U.S. Geological Survey

SUBJECT: U.S. Geological Survey TRIGA Reactor, Docket Number 50-274, License Number R-113, License Amendment Request LAR 14, Supplemental Information Letter 02 Provided in Response to Audit Visit on 2020-10-15

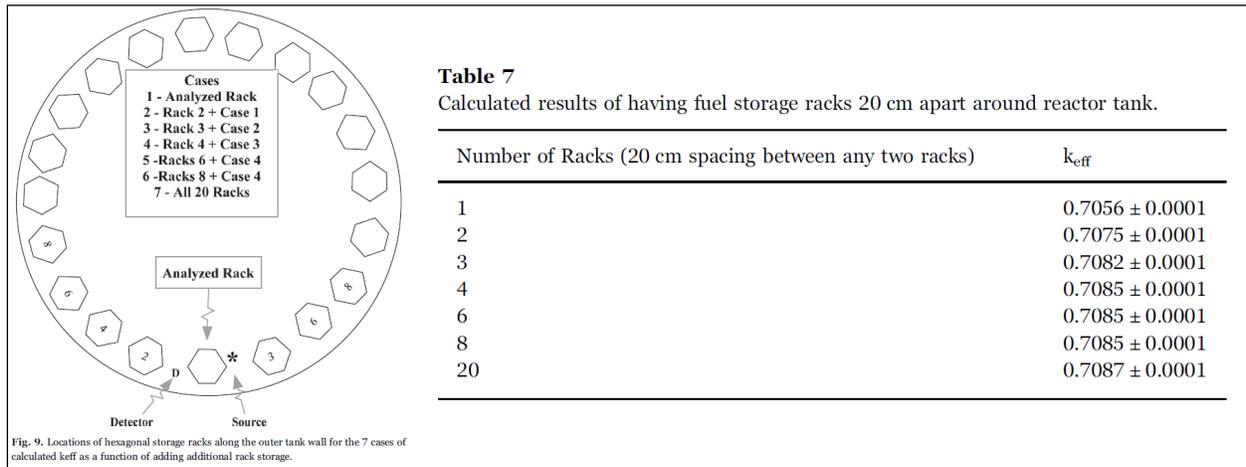
Also included from the publication, and more relevant to the 20 centimeter parameter established, figure 9 shows the arrangement of racks in the reactor tank along the interior wall analyzed at 20 centimeter spacing with table 7 showing the results of the analysis:

The publication presents additional data regarding the experimental setup and validation steps, but overall presents a demonstrable lack of neutron coupling between racks at the specified spacing.
